647.3916
Job Sheet 168031

Part Name: Deflector

DART AEROSPACE APICAL INDUSTRIES, INC. dba DART AEROSPACE	ENGINEERING CHANGE NOTICE NO. 04948				SHEET 1 OF 2	
	DWG NO. 647.3900	REV: C	PREPARED BY: M. ANDECK	DATE: 05/04/15	EFFECT ON DWG ☐ INC. ☒ UNINC.	
	DWG TITLE: DEFLECTORS					
APPROVED BY: ENGR <i>[Signature]</i>		MFG <i>[Signature]</i>	QC <i>[Signature]</i>	EFF: CURRENT ORDER		
TRANSACTION CODES (TC): A-ADD C-CREATE R-REVISE D-DELETE		REASON: REVISED TOLERANCE AND NOTES				ECR: D-15-01

ENGINEERING CHANGE NOTICE NO.

SHEET 5, ZONE C6 IS:

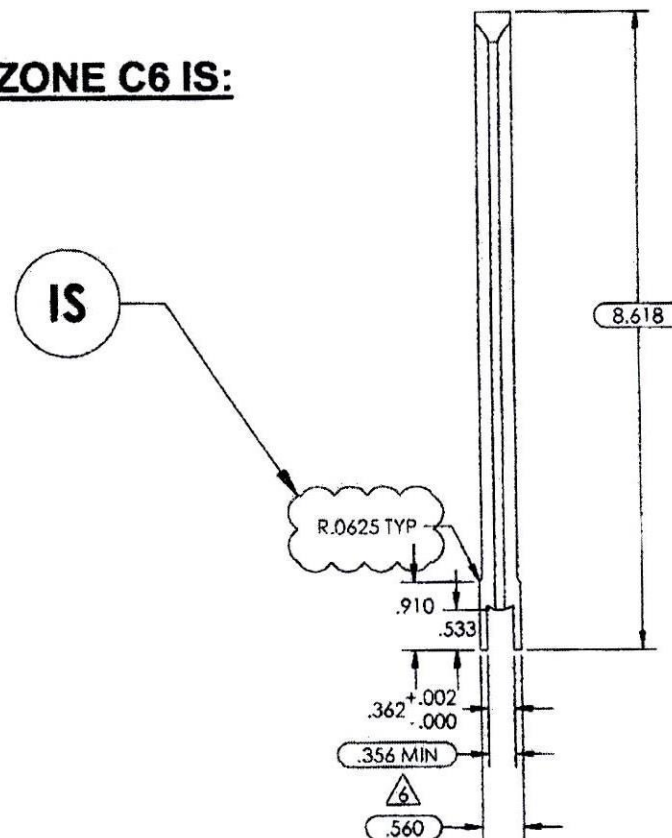
REASON: CHANGED P/N, DIMENSIONS & REVISED BOM
